Development Assessment Panel of City of Prospect

5.1 253 Churchill Road, Prospect – Four Storey Mixed Use Development comprising 16 dwellings and Ground Level Office, Car Parking and Landscaping (DA 050/248/2014)

AGENDA ITEM: 5.1

Proposal: Four Storey Mixed Use Development comprising 16 dwellings and Ground Level Office, Car Parking and Landscaping (DA 050/248/2014)

1 GROUND FLOOR & SITE PLAN
A104 Scale 1:100

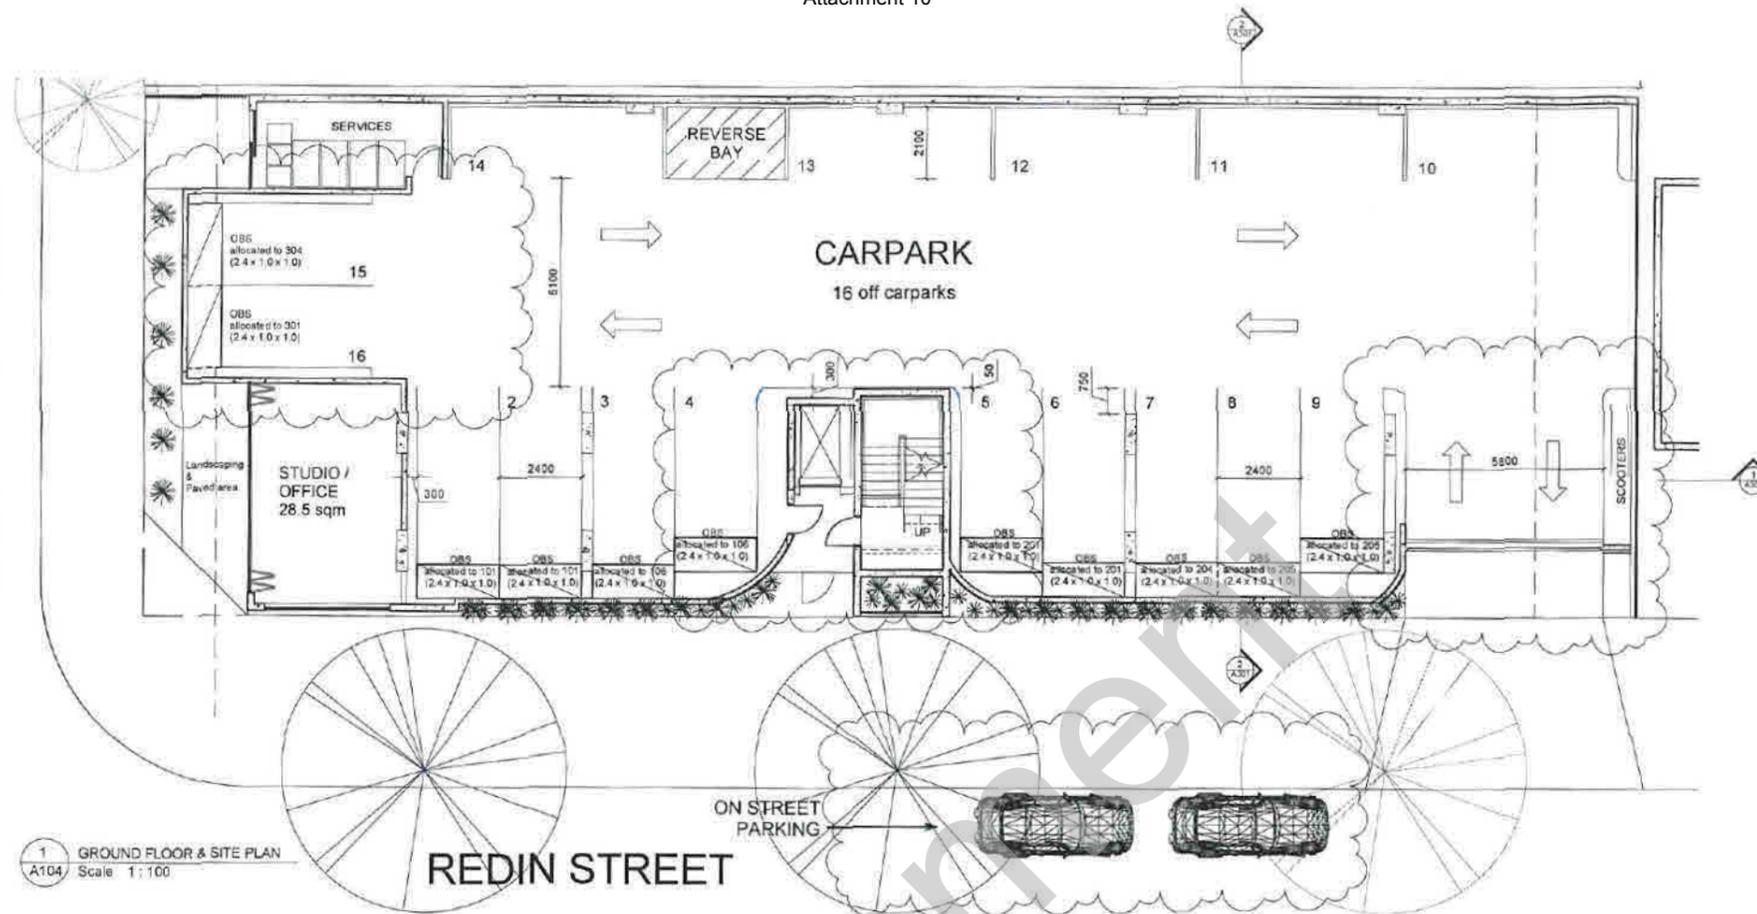
DPTI has received the amended plan (refer Loucas Zahos Architects, Drawing A104, Revision P4, dated 06/11/15) and associated Traffic and Parking Assessment undertaken by Phil Weaver & Associates (dated 6/11/15).

DPTI notes that the amended site plan provides access to Redin Street approximately 36 metres from the Churchill Road property boundary. DPTI considers this access to have negligible impacts to the free flow of traffic on Churchill Road. All existing access points to Churchill Road should be closed and reinstated with kerb and gutter.

1. The access point to Redin Street shall be designed in accordance with Loucas Zahos Architects Ground, Site & Level 1 Plan, Drawing A104, Revision P4, dated 06/11/15.

Figure 1: B85 design vehicle reversing from space 15

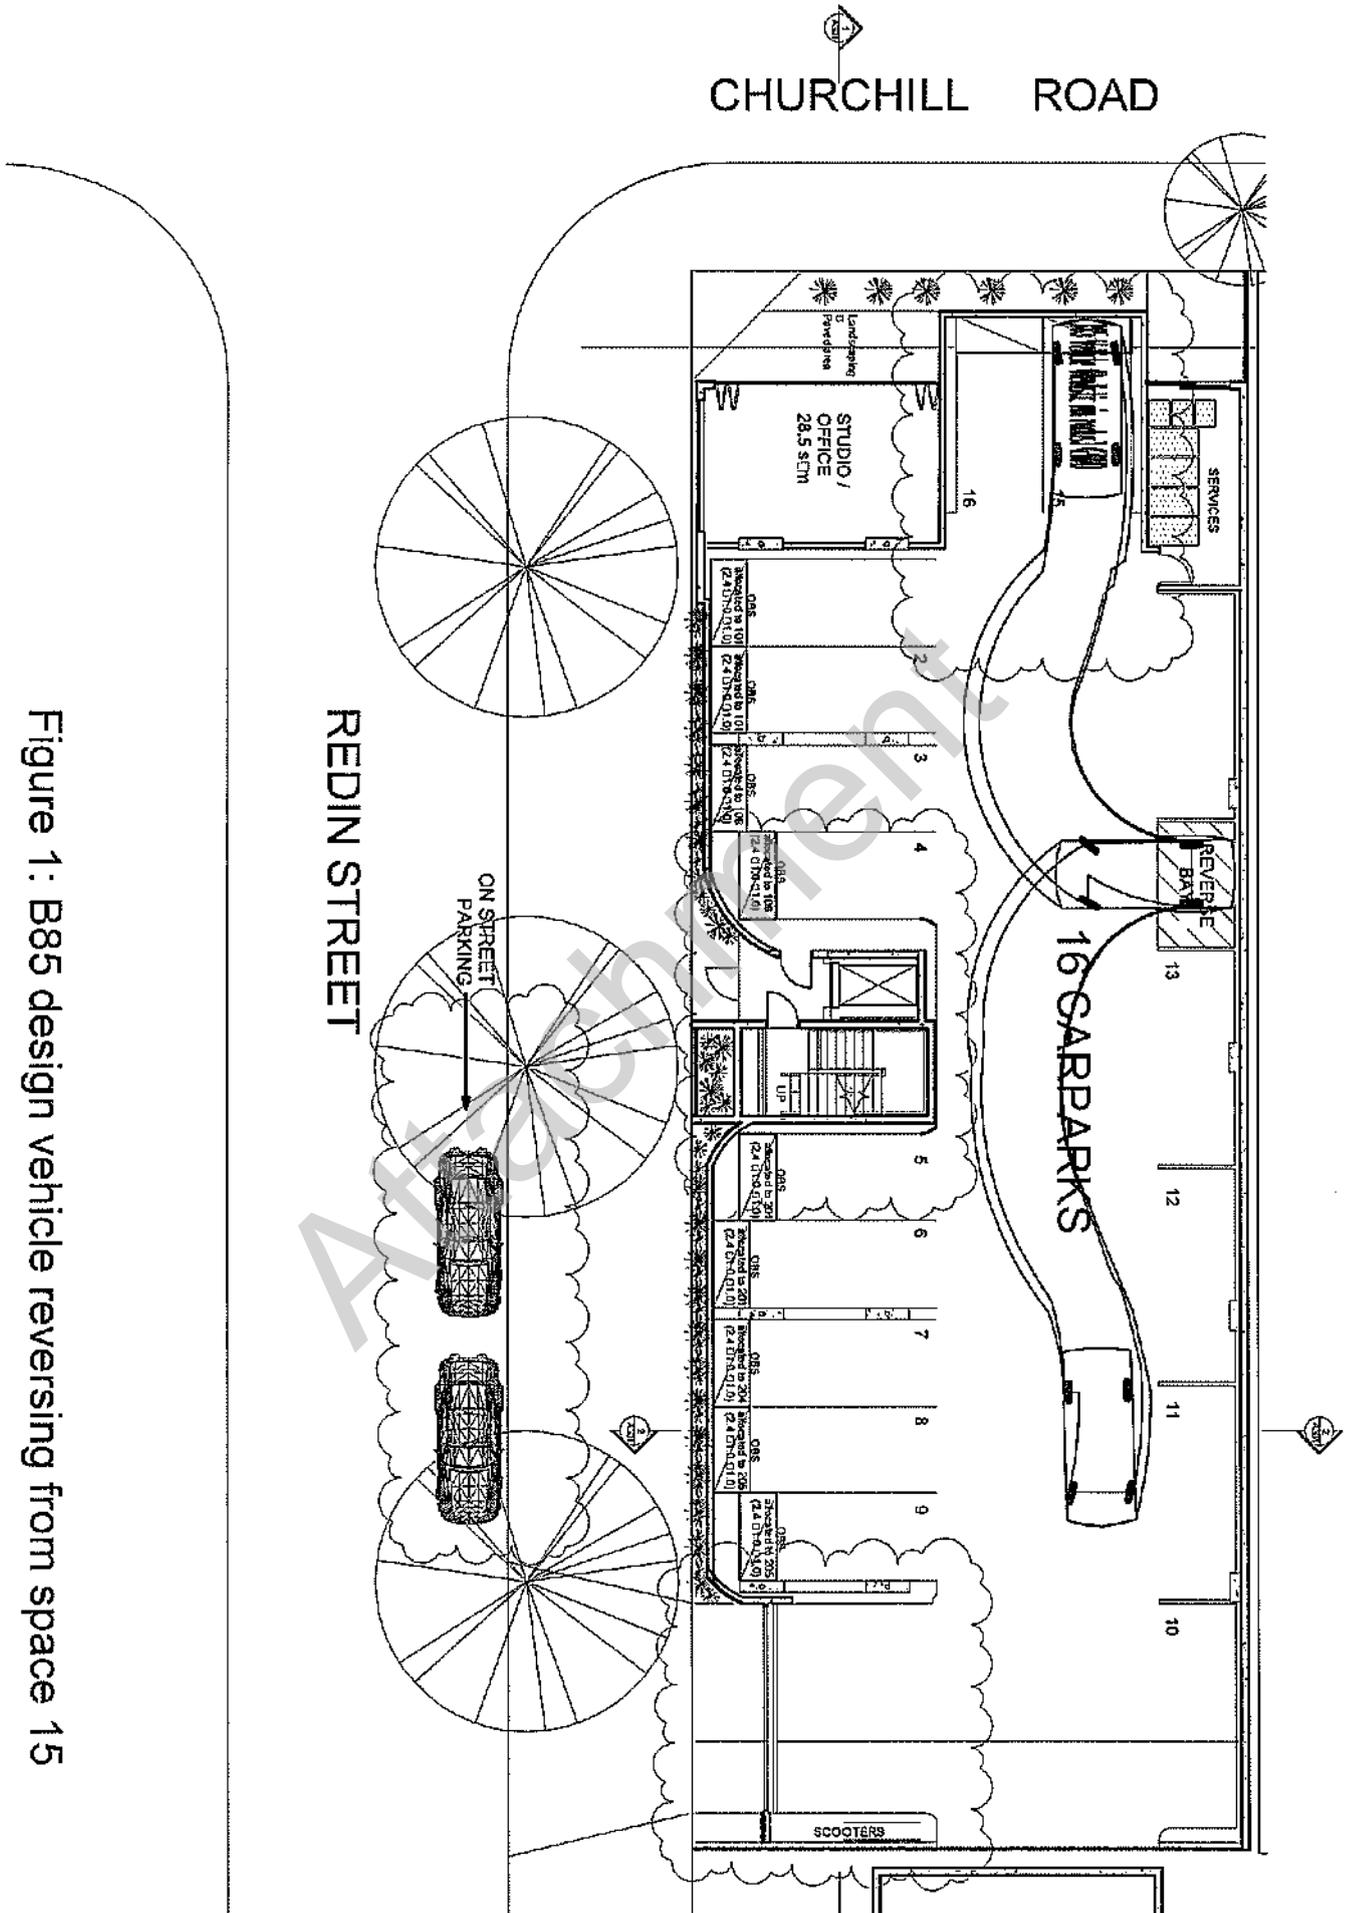
- Figure 1: the ability of the be B85 design vehicle to be reversed from space 15 and exit the site in a forward direction,
- Figure 2: the ability of the be B85 design vehicle to be reversed from space 16 and exit the site in a forward direction,
- Figure 3: the ability of the B85 design vehicle to be reversed from space 1 and exit the site in a forward direction,
- Figure 4: the ability of the B85 design vehicle to be reversed from space 3 and exit the site in a forward direction,
- Figure 5: the ability of the B85 design vehicle to access space 14 and to both enter and exit the site in a forward direction,
- Figure 6: the ability of a small car to access space 10 and for the driver or passengers to exit the car, and
- Figure 7: the ability of the B85 design vehicle to use the dedicated reversing area to turn on site.

Figure 8: Possible alternative access location

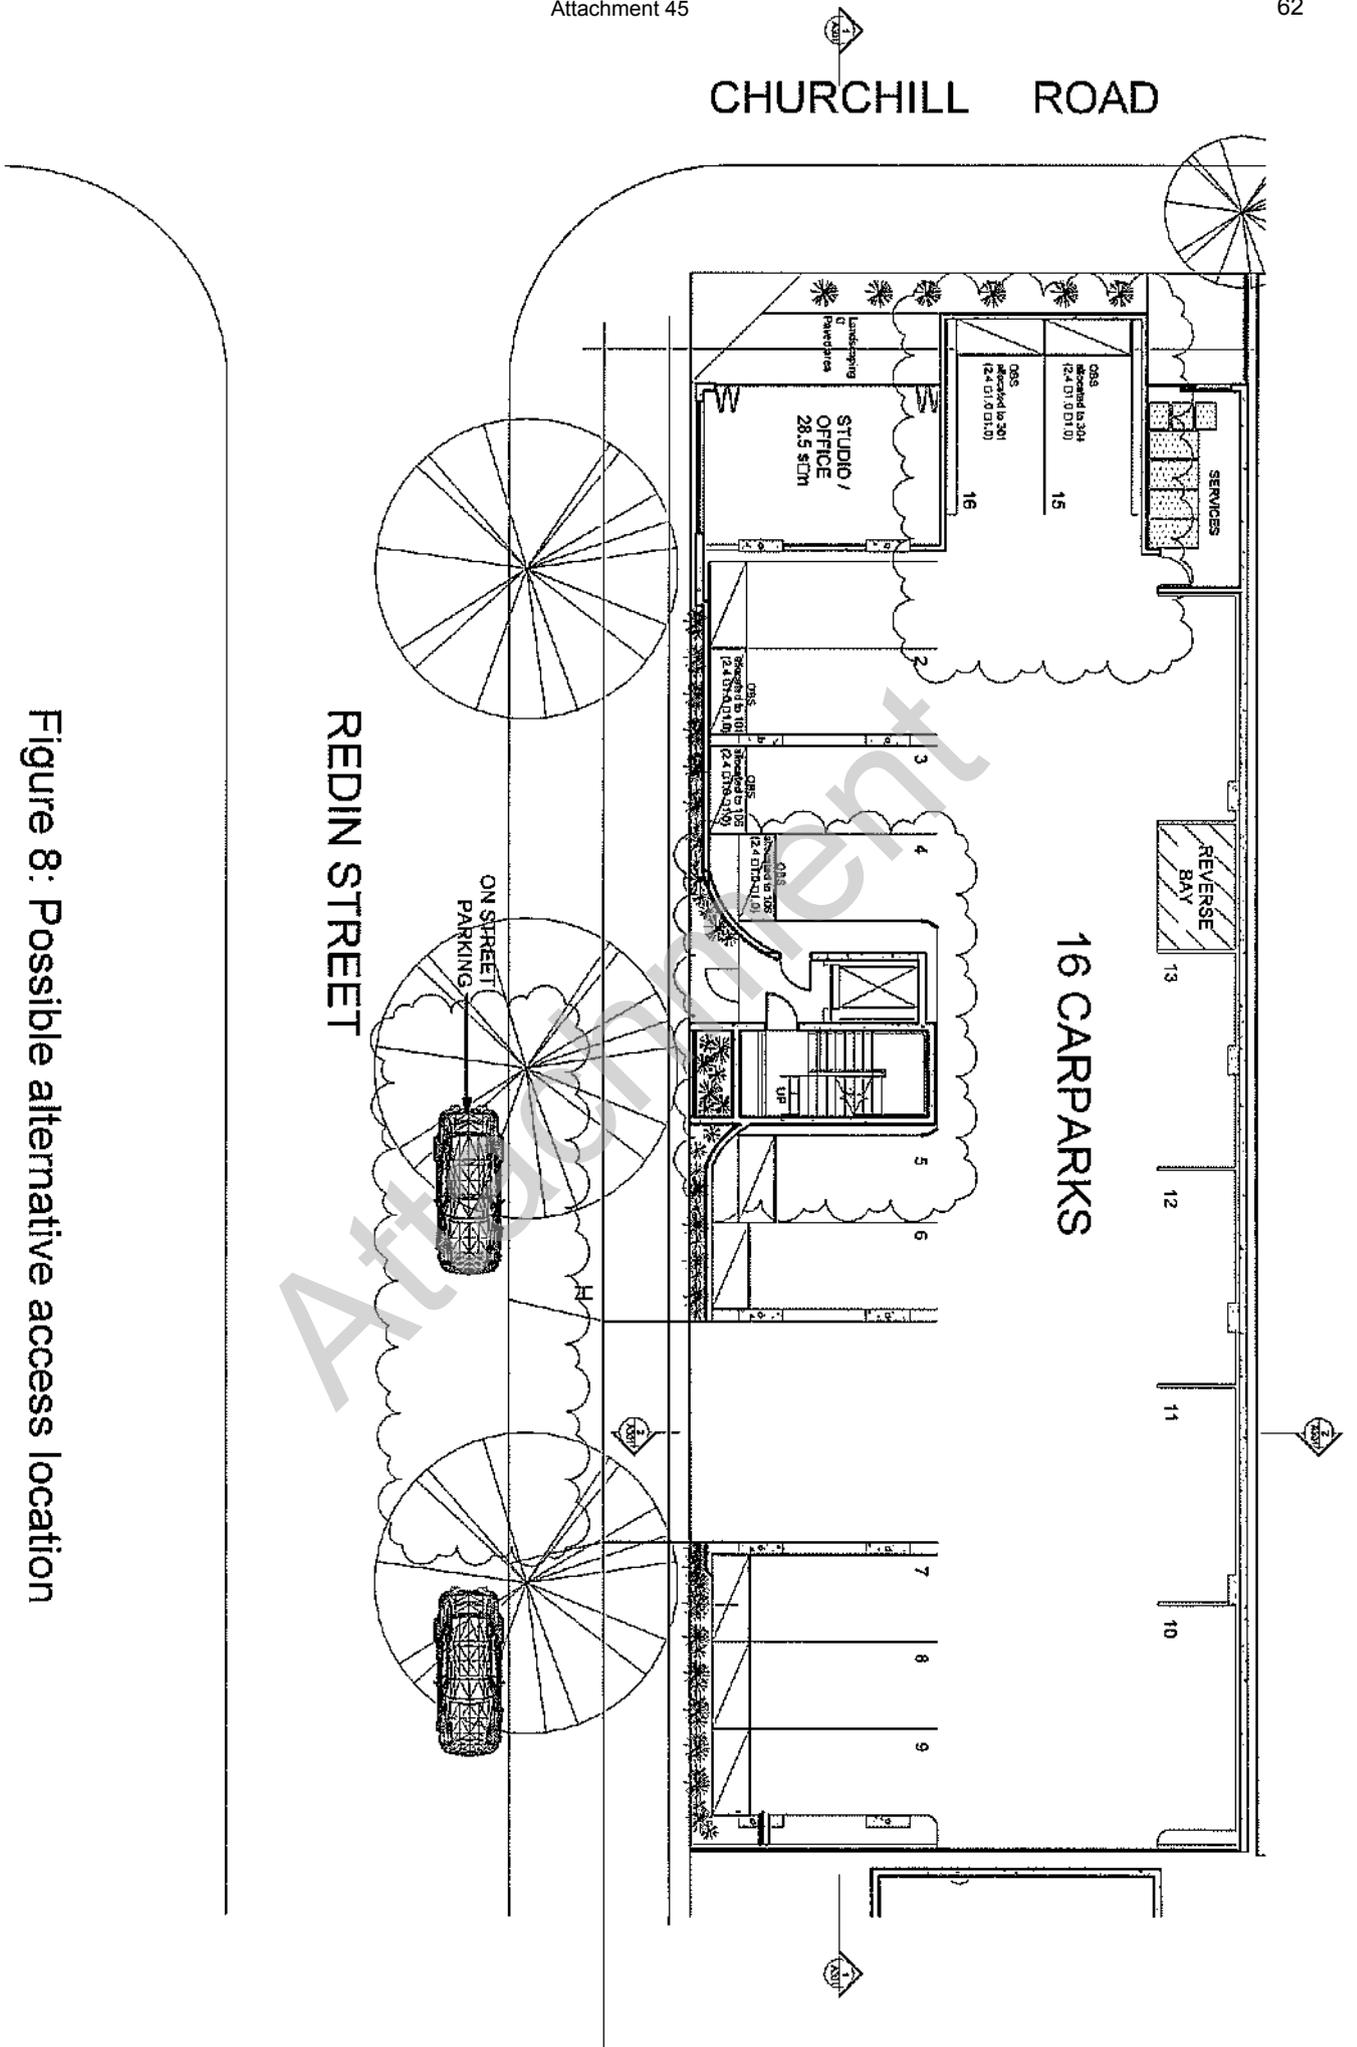
The report also identified an alternative access location as shown in Figure 8. Whilst no objection would be raised to this design, DPTI recommends that all on-street parking located on the northern side of Redin Street, west of the access, is banned along with the provision of turning profiles indicating that parks 7-9 and 10 can still be conveniently accessed. In addition a clear 1.0m separation should be provided from the adjacent stobie pole.

The proposed location of the access point at the eastern end of the site may conflict with an existing street tree and would therefore be subject to more detailed review. However, in the event that the access point would conflict with the street tree there would be an opportunity to relocate the access point slightly further to the west as identified in Figure 8. This figure is also attached to the report.
